**LEE'S SUMMIT MIDDLE SCHOOL #4**  
LEE'S SUMMIT R-7 SCHOOL DISTRICT

PACKAGE 3 - BUILDING & SITE  
10/08/20  
REVISIONS  
1 ADDENDUM 002 10/19/20  
2 PR 004 11/9/21

13-20102-00  
ELECTRICAL SITE PLAN - AREA 2

**E1.02**

1 ELECTRICAL SITE PLAN - NORTH  
 1" = 40'-0"

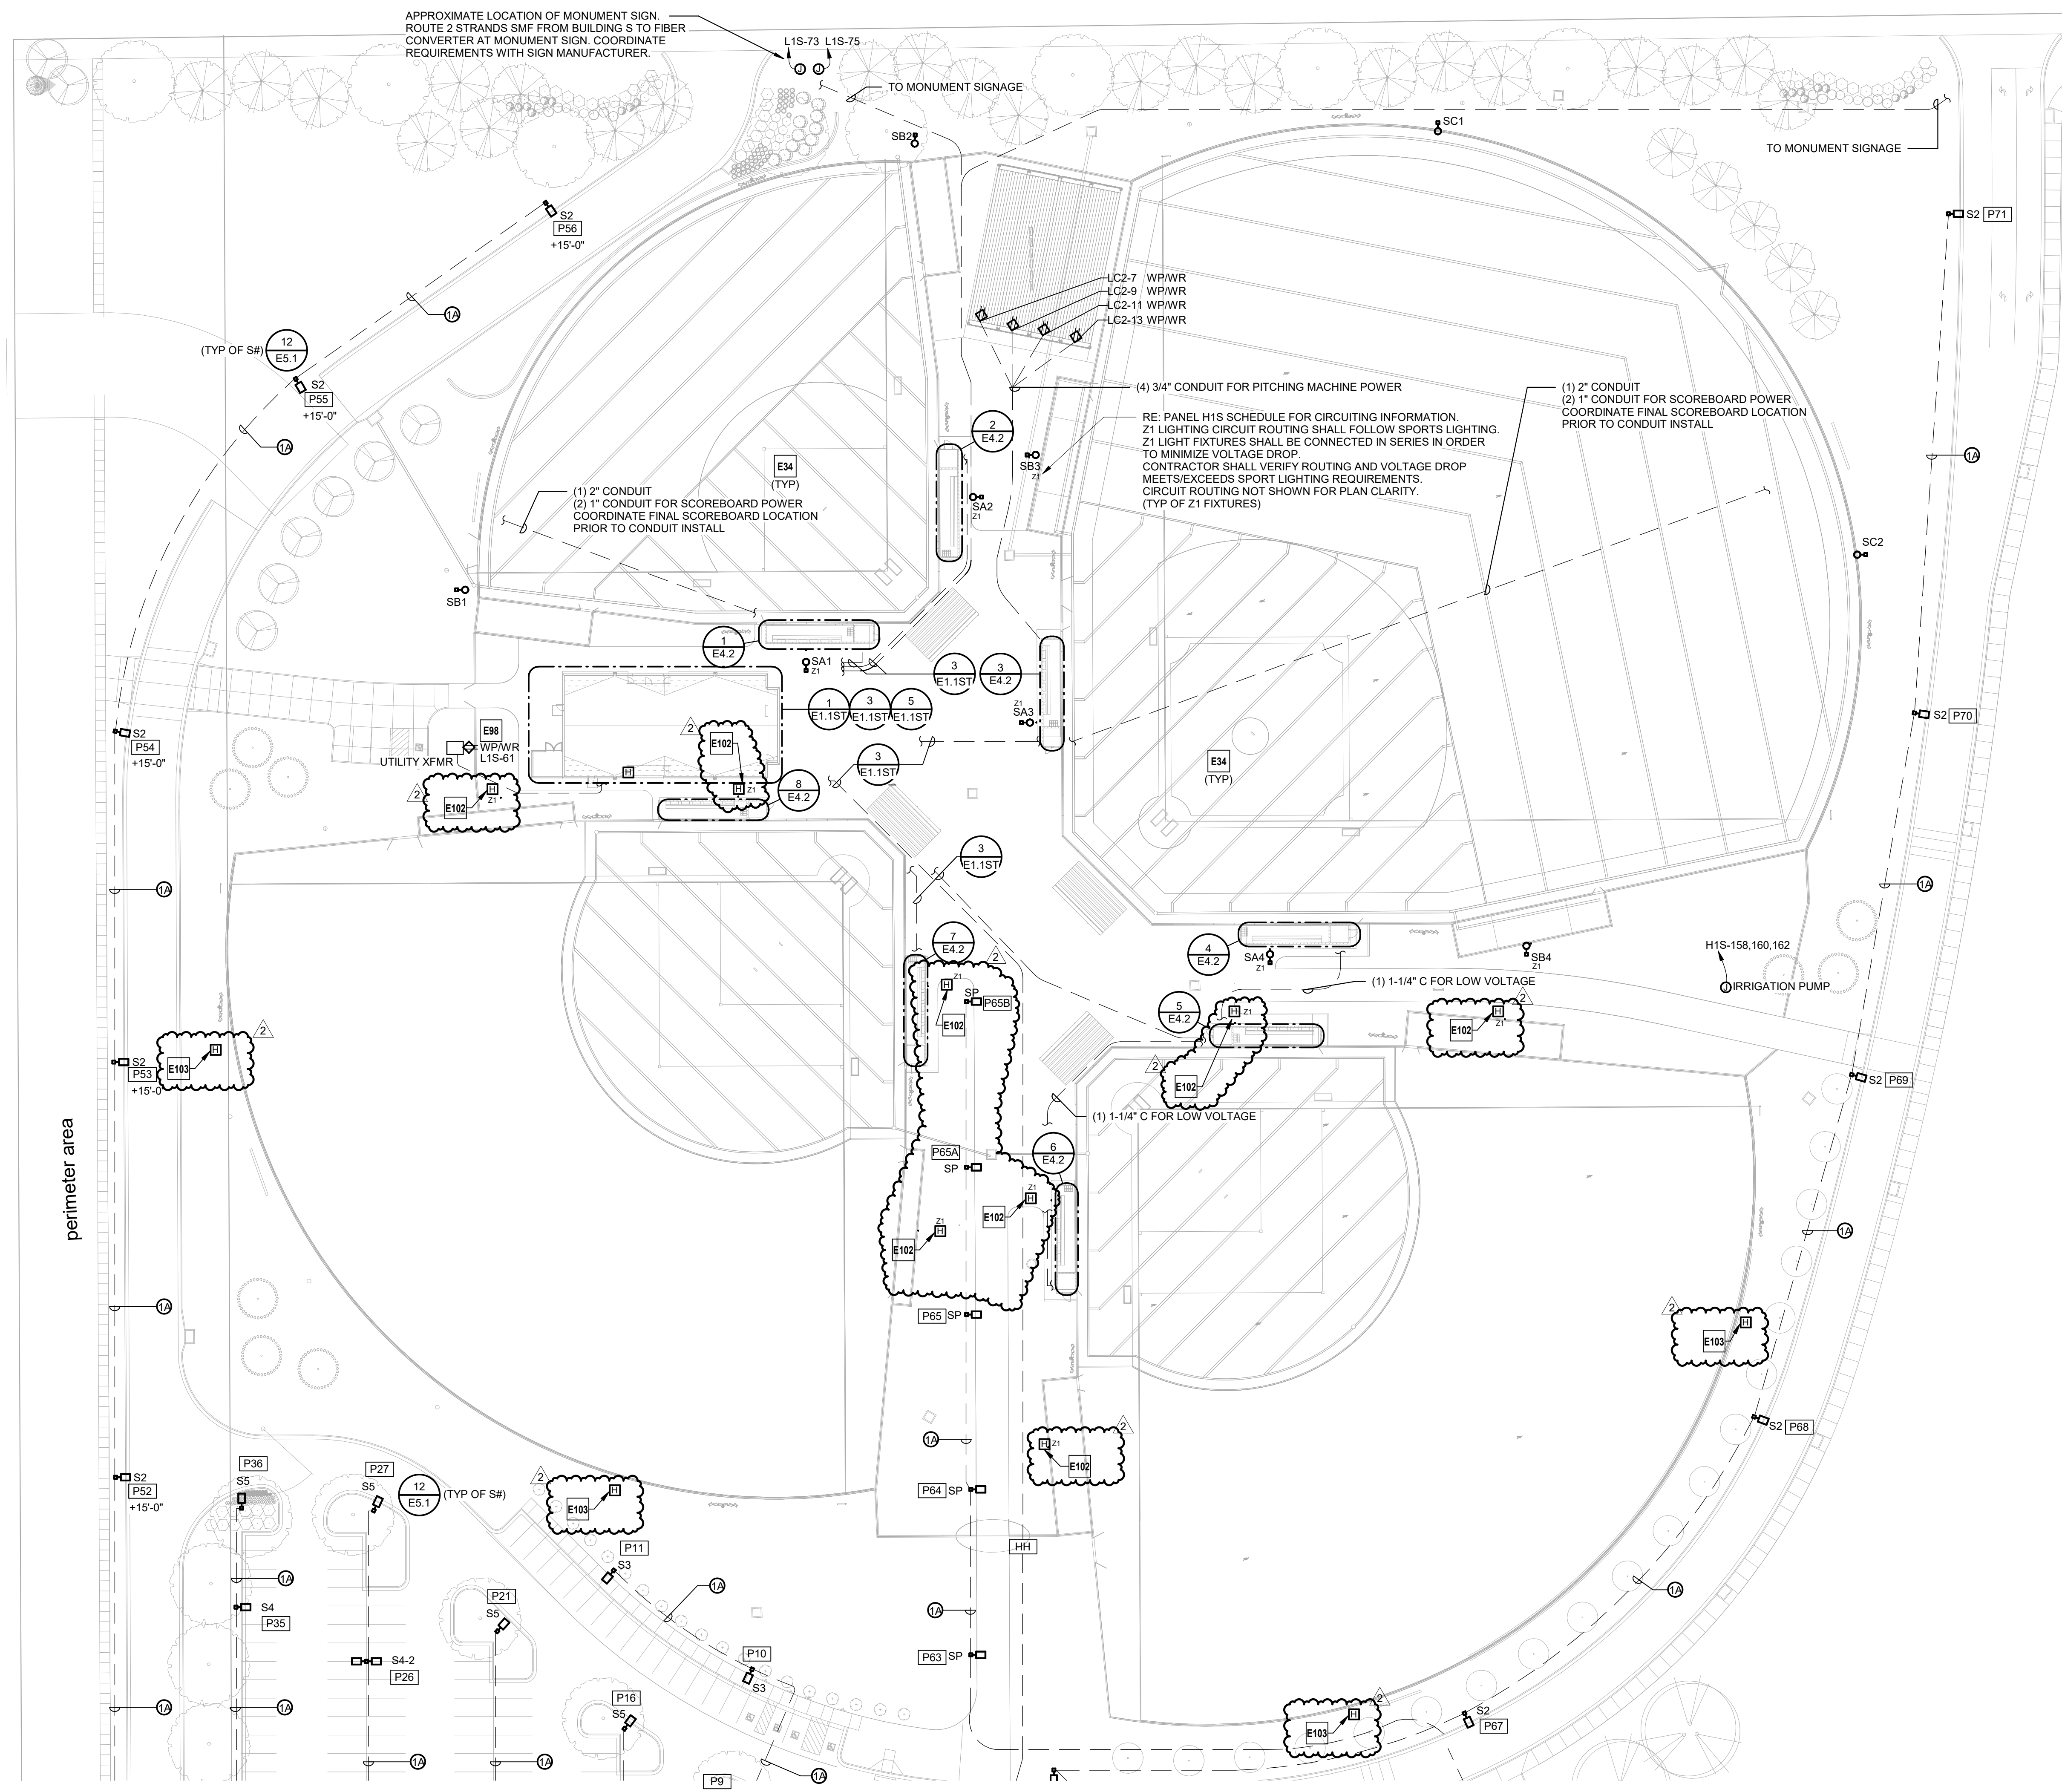
- E98 PROVIDE PEDESTAL MOUNTED RECEPTACLE TO SERVE IRRIGATION CONTROLLER. COORDINATE LOCATION WITH ARCHITECT.
  - E102 SOUTHERN BASEBALL/SOFTBALL FIELD(S) SPORTS LIGHTING POLES HAVE BEEN REMOVED FROM PROJECT SCOPE. CONTRACTOR TO PROVIDE PROVISIONS FOR FUTURE SPORTS LIGHTING POLES AT SOUTHERN BASEBALL/SOFTBALL FIELD(S). PROVIDE (1) HAND HOLE, (1) 1" CONDUIT WITH PULL STRING AND (1) 3/4" CONDUIT WITH PULL STRING (FOR FUTURE POLE MOUNTED SECURITY LIGHTING) PER FUTURE SPORTS LIGHTING POLE LOCATION. CONDUITS TO BE ROUTED TO CONCESSION STAND AND STUBBED UP AND CAPPED NEAR CONDUITS FOR SPORTS LIGHTING POLES THAT ARE IN SCOPE.

- E103 SOUTHERN BASEBALL/SOFTBALL FIELD(S) SPORTS LIGHTING POLES HAVE BEEN REMOVED FROM PROJECT SCOPE. CONTRACTOR TO PROVIDE PROVISIONS FOR FUTURE SPORTS LIGHTING POLES AT SOUTHERN BASEBALL/SOFTBALL FIELD(S). PROVIDE (1) HAND HOLE AND (1) 1" CONDUIT WITH PULL STRING PER FUTURE SPORTS LIGHTING POLE LOCATION. CONDUITS TO BE ROUTED TO CONCESSION STAND AND STUBBED UP AND CAPPED NEAR CONDUITS FOR SPORTS LIGHTING POLES THAT ARE IN SCOPE.

1 ELECTRICAL SITE PLAN - AREA 2  
1" = 40'-0"

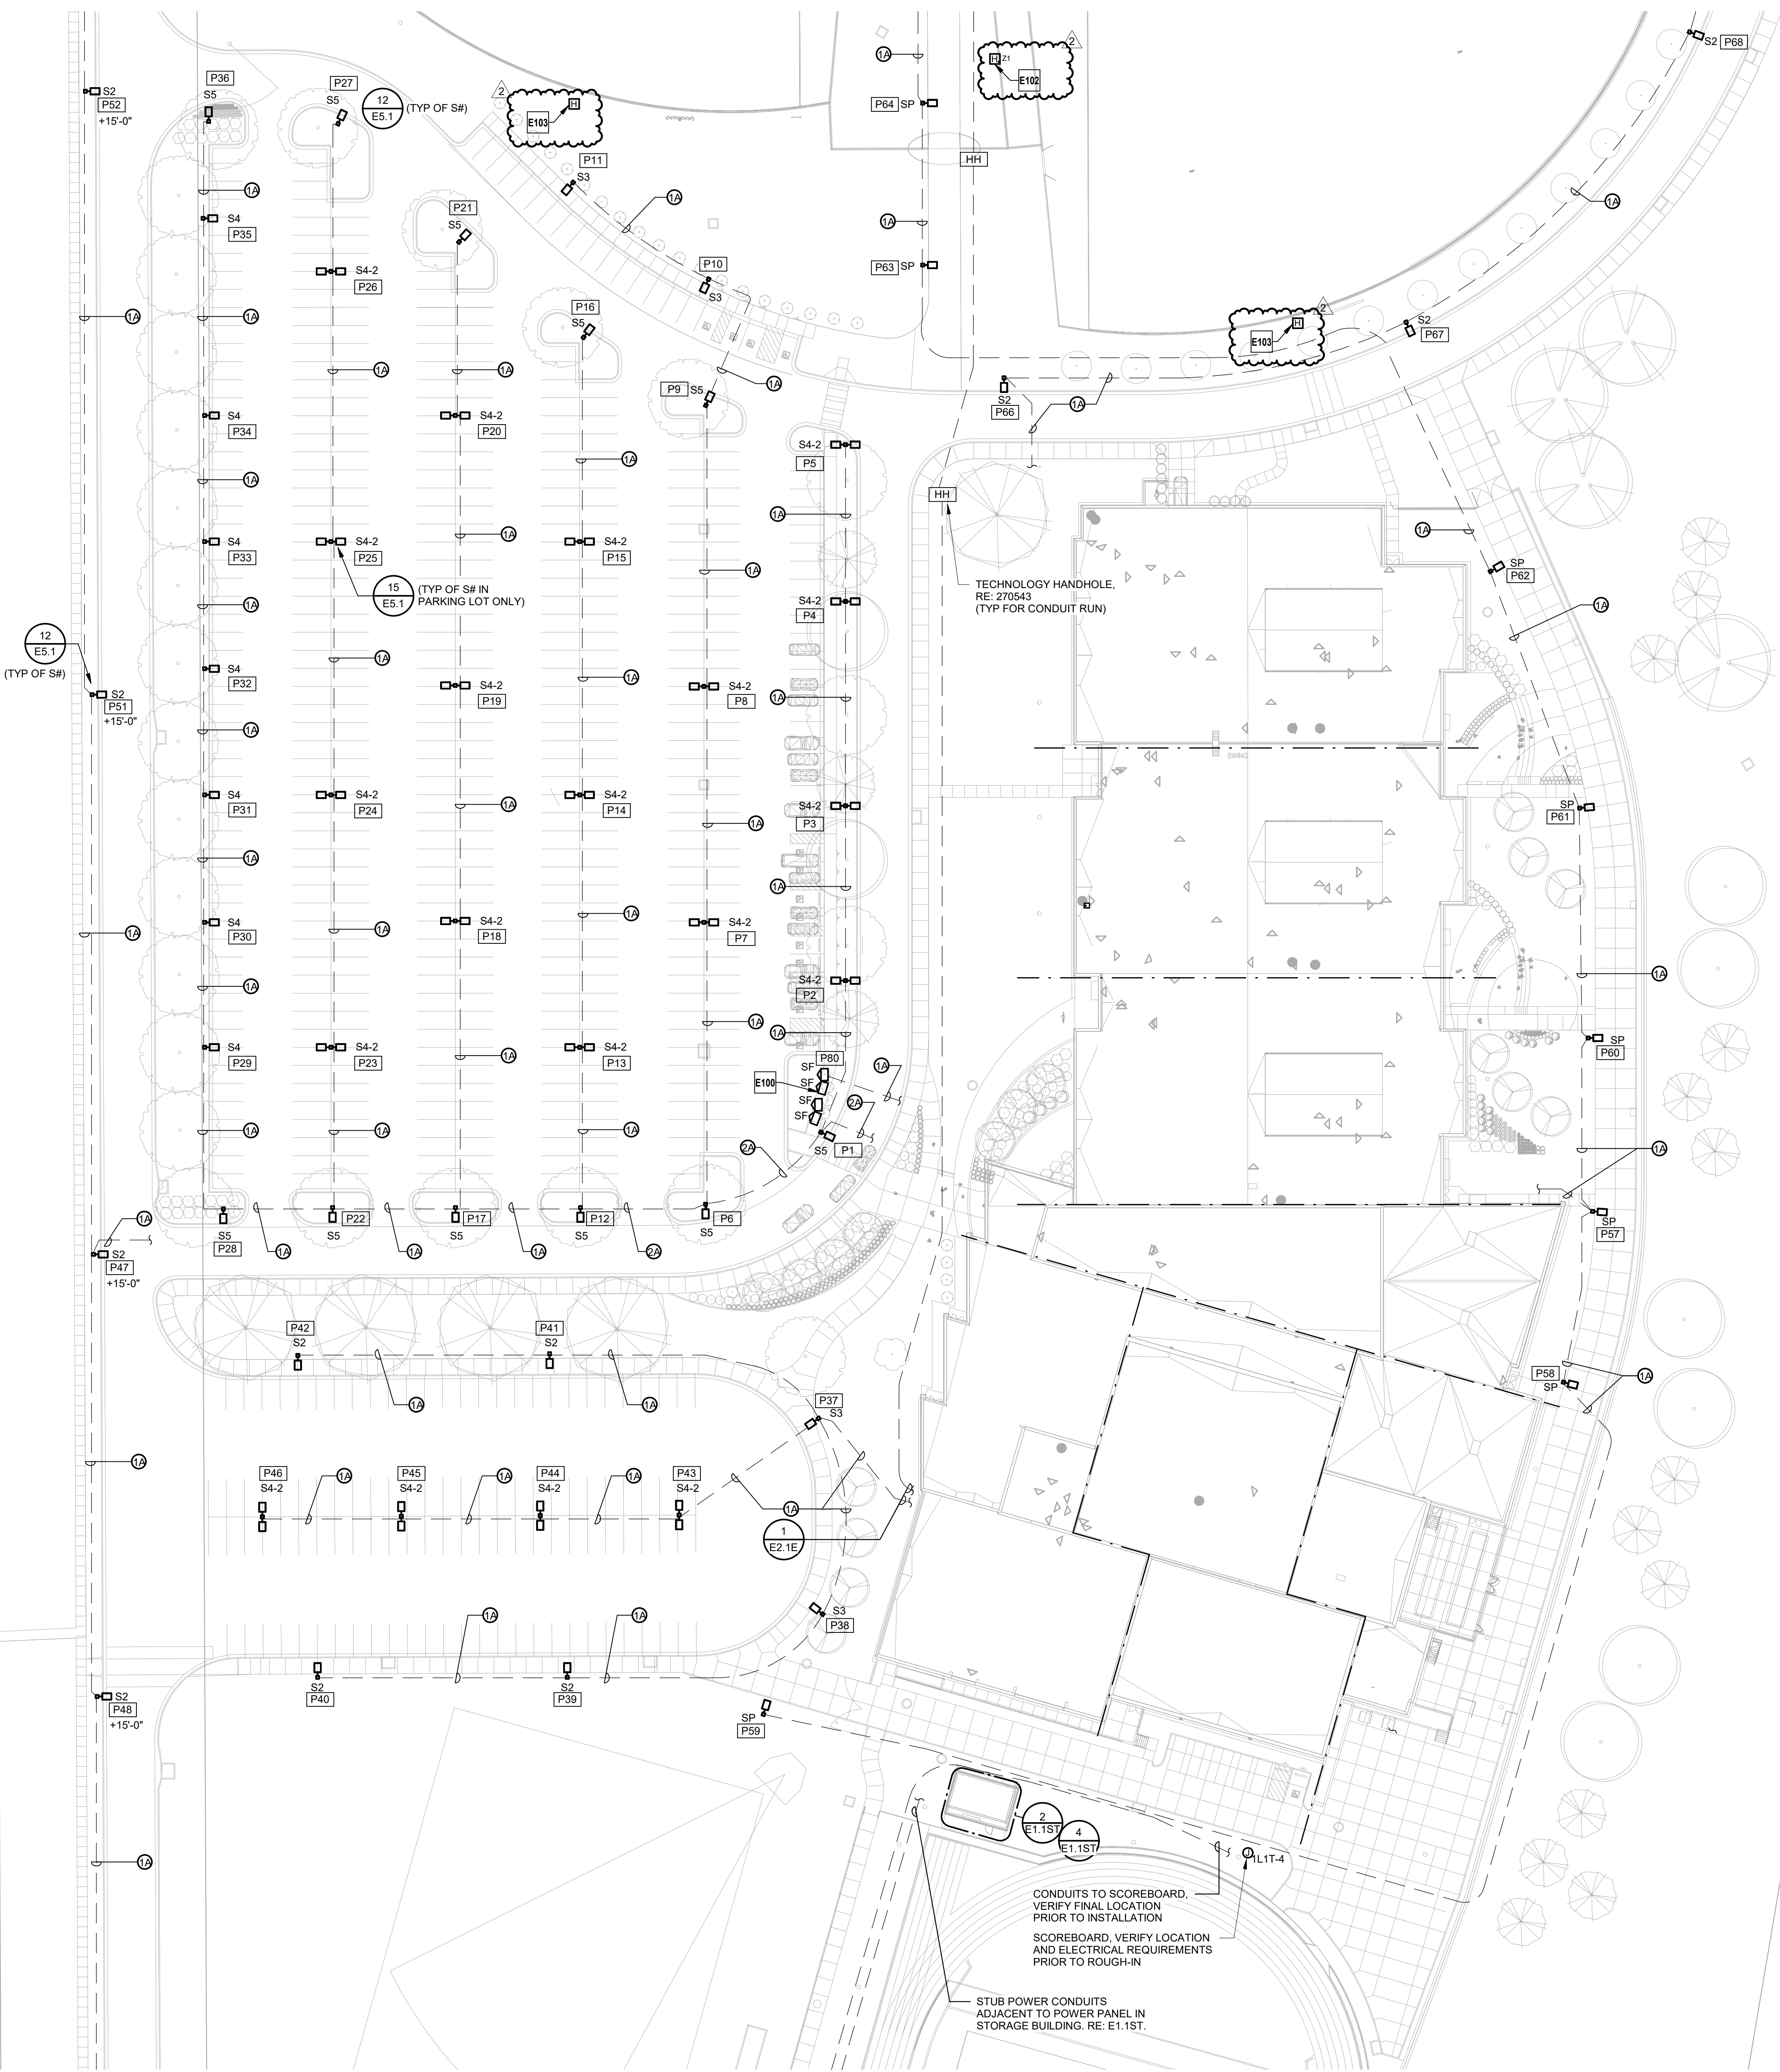
- E102 SOUTHERN BASEBALL/SOFTBALL FIELD(S) SPORTS LIGHTING POLES HAVE BEEN REMOVED FROM PROJECT SCOPE. CONTRACTOR TO PROVIDE PROVISIONS FOR FUTURE SPORTS LIGHTING POLES AT SOUTHERN BASEBALL/SOFTBALL FIELD(S). PROVIDE (1) HAND HOLE (1) 1" CONDUIT WITH PULL STRING AND (1) 3/4" CONDUIT WITH PULL STRING (FOR FUTURE POLE MOUNTED SECURITY LIGHTING) PER FUTURE SPORTS LIGHTING POLE LOCATION. CONDUITS TO BE ROUTED TO CONCESSION STAND AND STUBBED UP AND CAPPED NEAR CONDUITS FOR SPORTS LIGHTING POLES THAT ARE IN SCOPE.

- E103 SOUTHERN BASEBALL/SOFTBALL FIELD(S) SPORTS LIGHTING POLES HAVE BEEN REMOVED FROM PROJECT SCOPE. CONTRACTOR TO PROVIDE PROVISIONS FOR FUTURE SPORTS LIGHTING POLES AT SOUTHERN BASEBALL/SOFTBALL FIELD(S). PROVIDE (1) HAND HOLE AND (1) 1" CONDUIT WITH PULL STRING PER FUTURE SPORTS LIGHTING POLE LOCATION. CONDUITS TO BE ROUTED TO CONCESSION STAND AND STUBBED UP AND CAPPED NEAR CONDUITS FOR SPORTS LIGHTING POLES THAT ARE IN SCOPE.
